SERVICE BULLETIN # 00166

SUBJECT: GIII Loading Decal Discrepancy

MODELS: GIII Venders from P.O. 1488 through P.O. 1491-1400

GIII Loading Label (922828 rev 2)

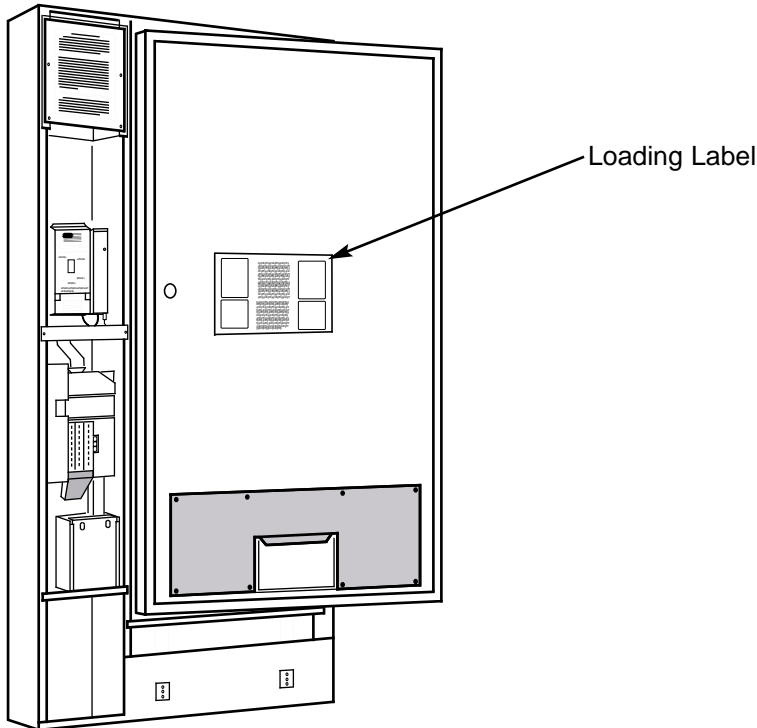
The incorrect loading decal (923433-1.1) was installed on the following production runs 1488-A through 1491-1400. The correct loading decal should be 931,303,021.

923433-1.1 <i>(incorrect decal)</i>	931,303,021 <i>(correct decal)</i>
Five packages have incorrect front retainer settings:	1. 20 oz Surge/Bolt	7
	2. 20 oz Powerade	9
	3. 16 oz Glass Fruitopia	10
	4. 16 oz Glass Straightwall	10
	5. 16 oz Can	9
